## United States Patent and Trademark Office

PPLICATION NO.	FILING DATE	FIRST NAMED INVENTOR	ATTORNEY DOCKET NO.	CONFIRMATION NO
10/766,391	01/28/2004	Douglas Dombrowski	DP-311282 3331	
22851 759	90 07/15/2005		EXAM	INER
DELPHI TECHNOLOGIES, INC.			LUONG, VINH	
M/C 480-410-20	02		ART UNIT	PAPER NUMBER
PO BOX 5052			ARTONII	FAPER NUMBER
TROY, MI 48007			3682

Application No.	Applicant(s)			
	10/766,391	DOMBROWSKI ET AL.			
Office Action Summary	Examiner	Art Unit			
	Vinh T. Luong	3682			
The MAILING DATE of this communication app Period for Reply	pears on the cover sheet with the c	correspondence address			
A SHORTENED STATUTORY PERIOD FOR REPL' THE MAILING DATE OF THIS COMMUNICATION.  - Extensions of time may be available under the provisions of 37 CFR 1.1 after SIX (6) MONTHS from the mailing date of this communication.  - If the period for reply specified above is less than thirty (30) days, a reply - If NO period for reply is specified above, the maximum statutory period of the period for reply within the set or extended period for reply will, by statute any reply received by the Office later than three months after the mailing earned patent term adjustment. See 37 CFR 1.704(b)

## **ATTACHMENT**

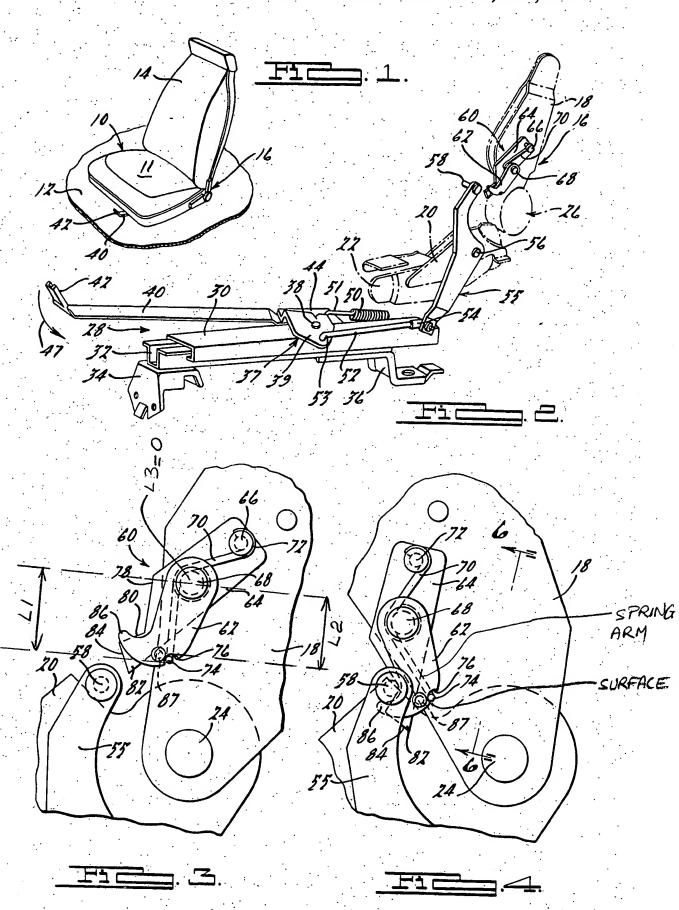
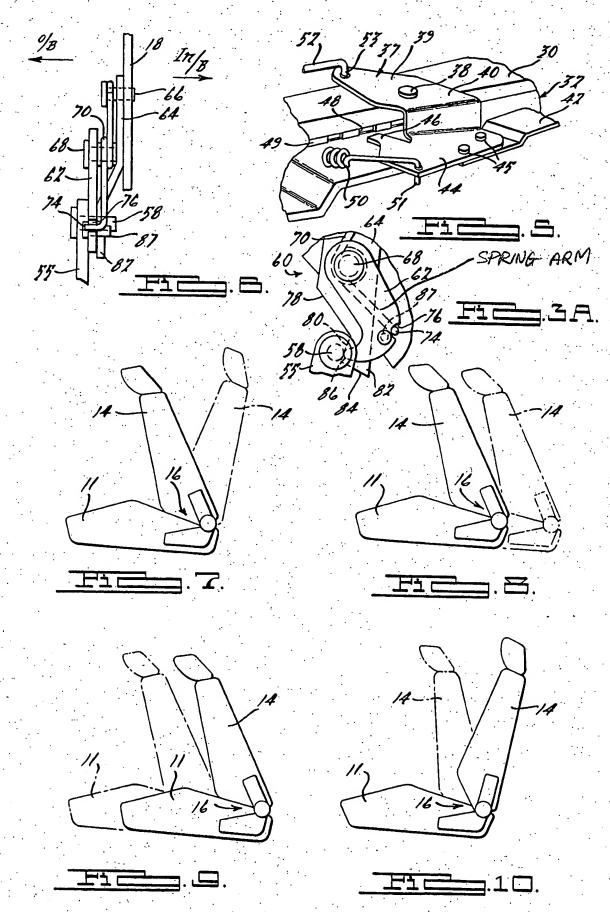
and a second position (Fig. 4), and a spring 70 having an arm (unnumbered. See

having a spring arm (Att.) that engages the notch 76 in the lever 62 to hold the lever 62 in

having a tangential spring arm (Att.) that is attached to a central coil (at 68 in Fig. 3) at

spring 70 being stressed so that the spring arm (Att.) holds the lever 62 in the first position when the distal end 74 is in the notch 76 while biasing the lever 62 toward the second position, the spring arm (Att.) moving the lever 62 to the second position when the distal end 74 is *partially* disengaged from the notch 76 (Fig. 4).

Regarding claim 4, the distal end 74 of the spring arm (Att.) when *partially* released from the notch 76 slides along a surface (Att.) of the lever 62 to bias the lever 62 to the second position.

Regarding claim 5, the distal end 74 of the spring arm 70 is a *substantially* perpendicular end portion of the spring arm (Att.), which when *partially* released from the notch 76 slides along a surface (Att.) of the lever 62 to bias the lever 62 to the second position.

Regarding claims 6 and 7, the spring arm (Att.) has a length L-1 (Att.) measured from its pivot to the distal end, wherein the lever has a length L-2 (Att. 2) measured from its pivot to the notch, and wherein the system has a length L-3 measured
